Access Compliance Report

Public Rights-of-Way

Intersection ID: 15579	Main Street: S_TRYON_ST	Cross Street: TRADE_PARK_CT	Location: N
ADA ID: BA6BCCDA778B	Ramp Type: PerpDiag	Initial Pass/Fail: Fail	Overall Compliance: No
			Severity Score: 13.75

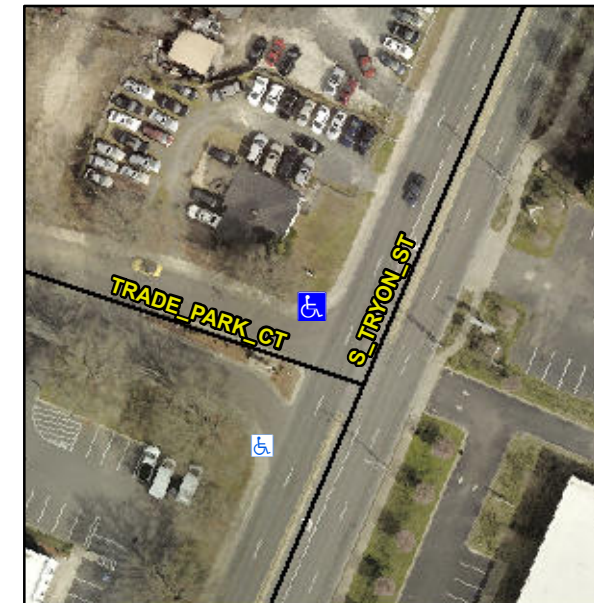
R304.2.2, R304.5.3

Compliance	Description	Data	Compliance	Description	Data
N/A	Ramp Length (in)	60.0	No	Ramp Slope (%)	9.2
Yes	Ramp Width (in)	48.0	No	Ramp XSlope (%)	2.6
N/A	Flare Type LT	N/A	N/A	Flare Type RT	N/A
N/A	Flare Slope LT (%)	N/A	N/A	Flare Slope RT (%)	N/A
N/A	Flare Traversable LT?	N/A	N/A	Flare Traversable RT?	N/A
N/A	Landing Length (in)	N/A	N/A	DWS Provided?	N/A
N/A	Landing Width (in)	N/A	N/A	DWS Contrast?	N/A
N/A	Landing Slope (%)	N/A	N/A	DWS Length (in)	N/A
N/A	Landing X Slope (%)	N/A	N/A	DWS Full Width?	N/A
N/A	Landing Curb? (Y/N)	N/A	N/A	DWS Offset (in)	N/A
N/A	Shared Landing?	N/A			
N/A	Gutter Ponding?	N/A	N/A	Gutter Slope (%)	N/A
N/A	Gutter Lip Ht (in)	N/A	N/A	Gutter X Slope (%)	N/A
N/A	Painted X Walk1?	No	N/A	Painted X Walk2?	No
	X Walk 1 Direction	To SW		X Walk 2 Direction	To SE
N/A	X Walk 1 Width (in)	N/A	N/A	X Walk 2 Width (in)	N/A
	X Walk 1 Slope (%)	0.3		X Walk 2 Slope (%)	3.1
	X Walk 1 X Slope (%)	3.5		X Walk 2 X Slope (%)	0.4

Remove & Replace Curb Ramp With Two New Directional Ramps or Equivalent.
